Access Compliance Report Public Rights-of-Way (Curb Ramps)

Main Street: N/A Cross Street: ROSSMOOR_CENTER_WAY Location: SW

ADA ID: RPRK211208120101 Ramp Type: Type 1 - Perpendicular Initial Pass/Fail: Pass Overall Compliance: No Severity Score: 0

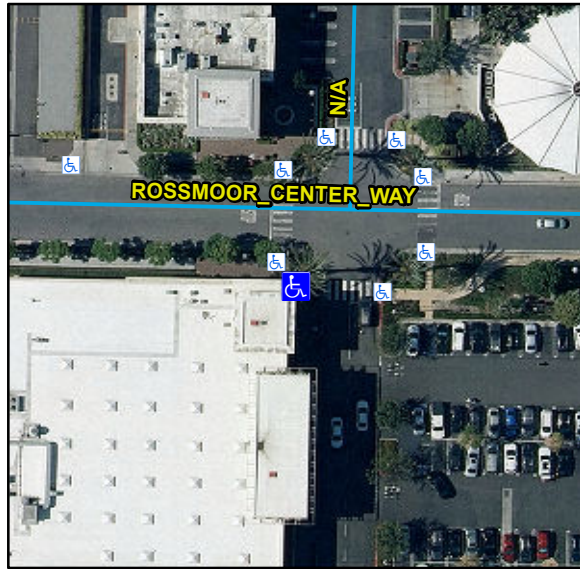
Remove & Replace Landing.
